Permit Comment Matrix Final for Review

EPA UIC Permit # CA10600001
 Operator: Panoche Energy Center, LLC
 Location: Section Sec 5 T15S R13E
 County/ State: Fresno / California

Panoche Wastewater Injection Schematic

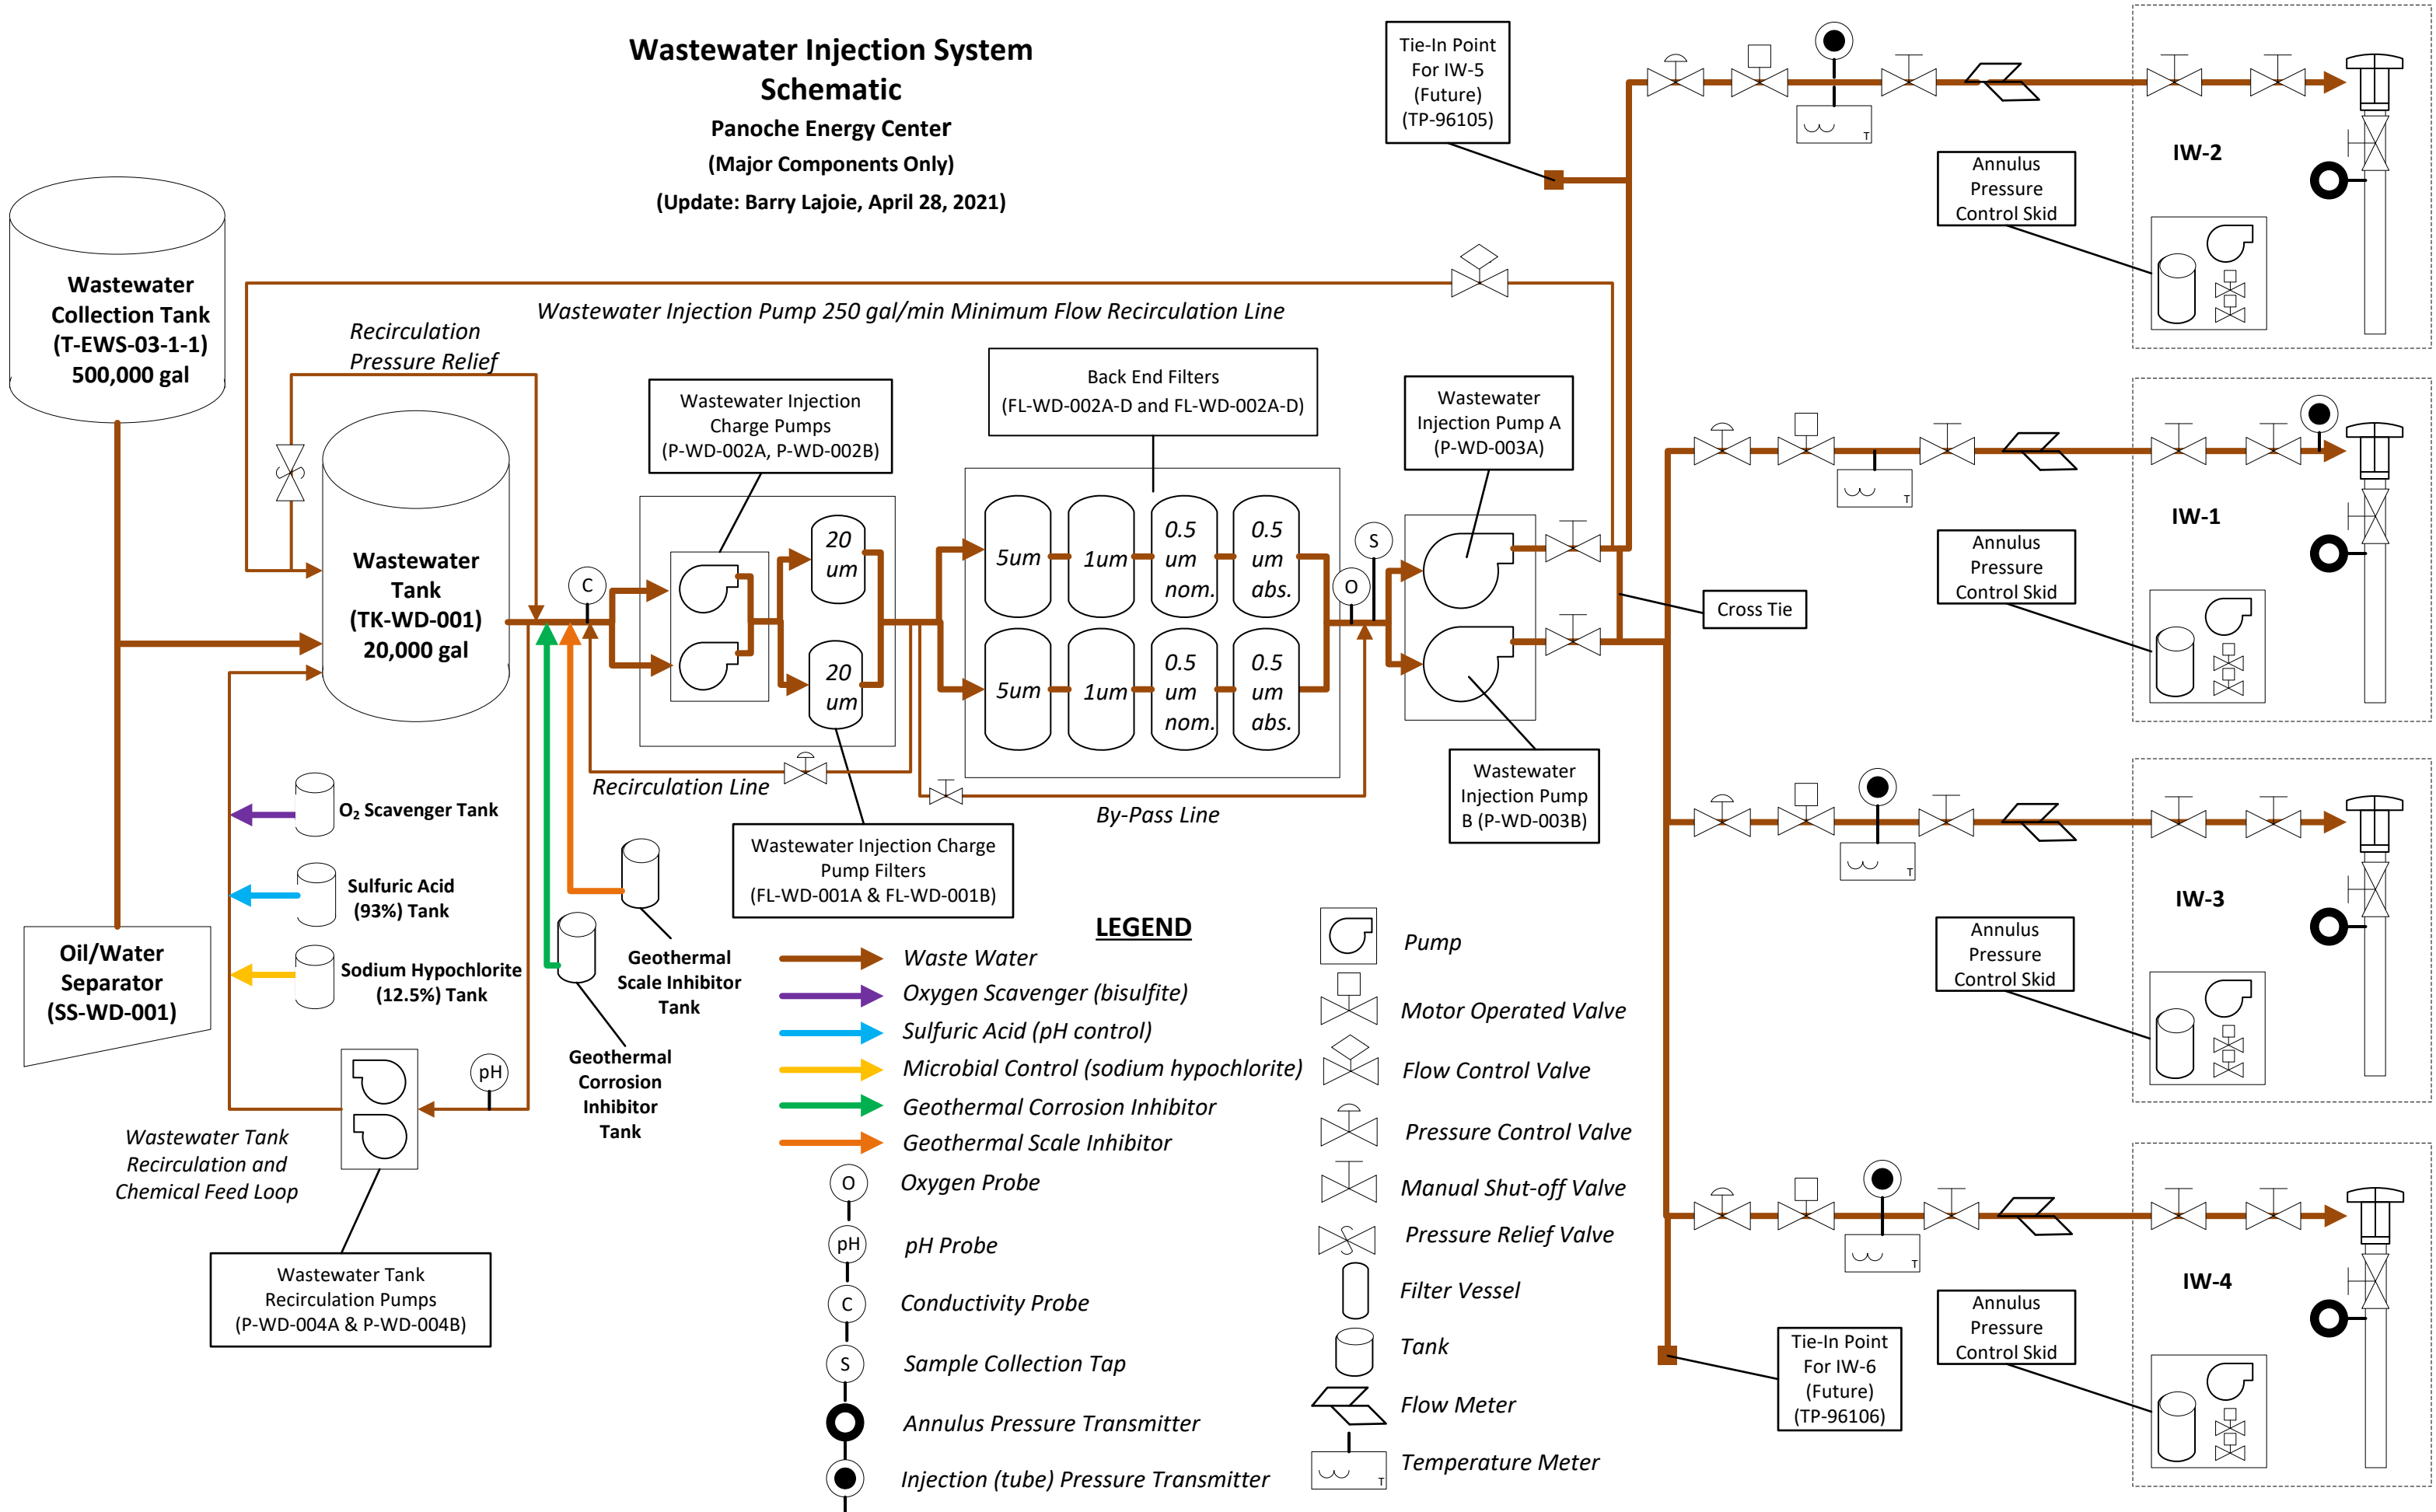
5 Monitoring Devices	a	<u>II.B.5.a</u> - "A tap on the discharge line between the injection pump and the wellhead or an alternative location proposed in a detailed written request by the Permittee and approved in writing by the EPA Director or their delegated representative for the purpose of obtaining representative samples of injection fluid; and"	<u>II.B.5.a</u> - PEC is requesting that this condition be changed to ... "A tap on the discharge line shall be located that provides for representative sampling of all wastewaters being injected downstream of any water treatment, either chemical or physical." The basis for this request is that the preferred location for the tap is downstream of all chemical addition and the back end filters and provides a sample that would provide a similar result as downstream of the injection pumps. The preferred location of the sample tap would never expose the sampler to pressures much greater than 100 psi while the location stated in the draft permit is 1950 – 2000 psi while injecting.

FIGURE M-1

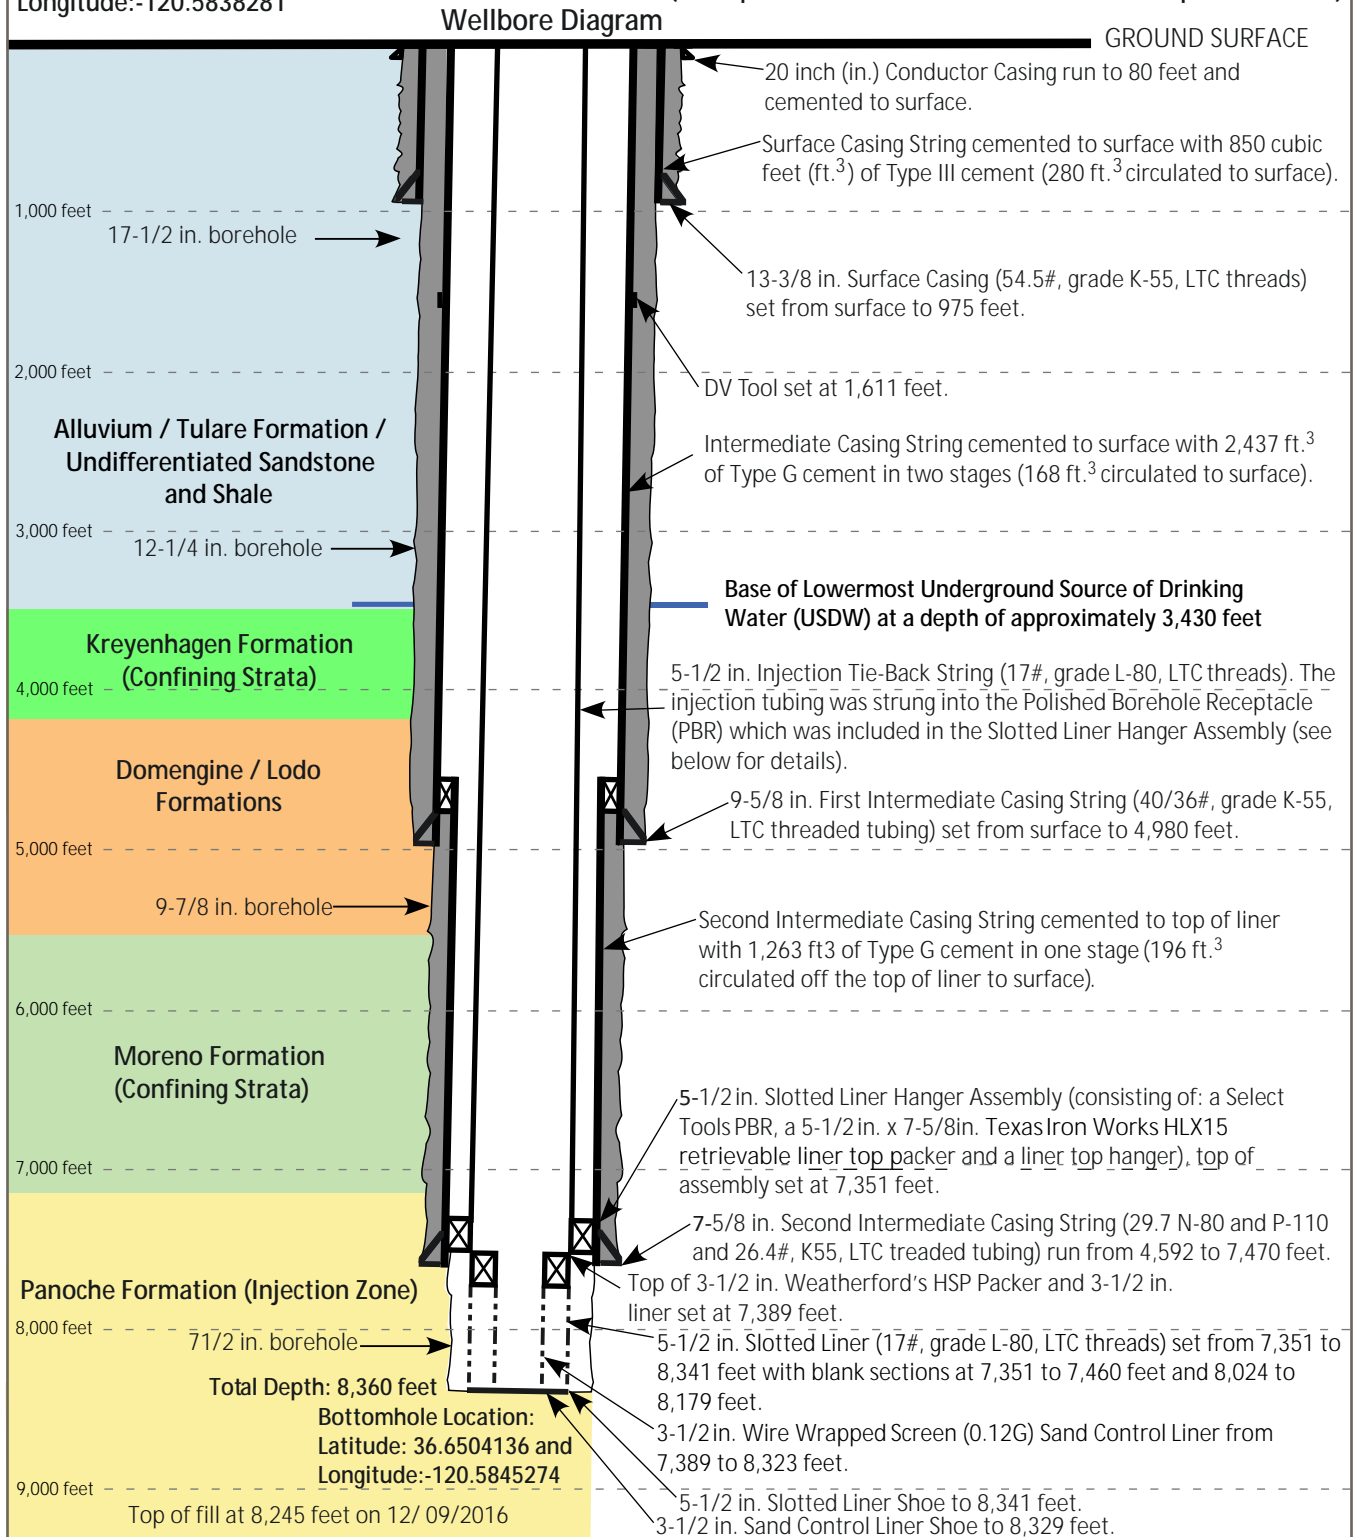
B CONDITIONS FOR EXISTING WELL AND FUTURE WELL CONSTRUCTION	2 Existing Well Construction Details		<u>II.B.2</u> - Well Construction Details	Please update the Appendix with the most current version of IW-1 (October 20, 2020) and IW-2 (November 5, 2020) schematics to incorporate into final permit. See Attachment 5 (PEC IW1 Schematic and PEC IW2 Schematic).
		3 Injection Formation Testing	a Pressure Fall Off Test (FOT)	<u>II.B.3.a.B</u> - "The Permittee shall conduct this FOT in Well IW2.." <u>II.B.3.a.E</u> - "Permittee shall conduct a FOT annually thereafter"	<u>II.B.3.a.B</u> - The FOT should produce similar results regardless of which well is used. PEC requests the flexibility to use wells other than IW2 for the FOT. PEC requests that "Well IW2" be replaced with ... "in either IW1, IW2, IW3, or IW4 as proposed in procedures submitted to EPA for approval ..." <u>II.B.3.a.E</u> - PEC requests that "annually be clarified to be within 9 to 15 months since the previous FOT"
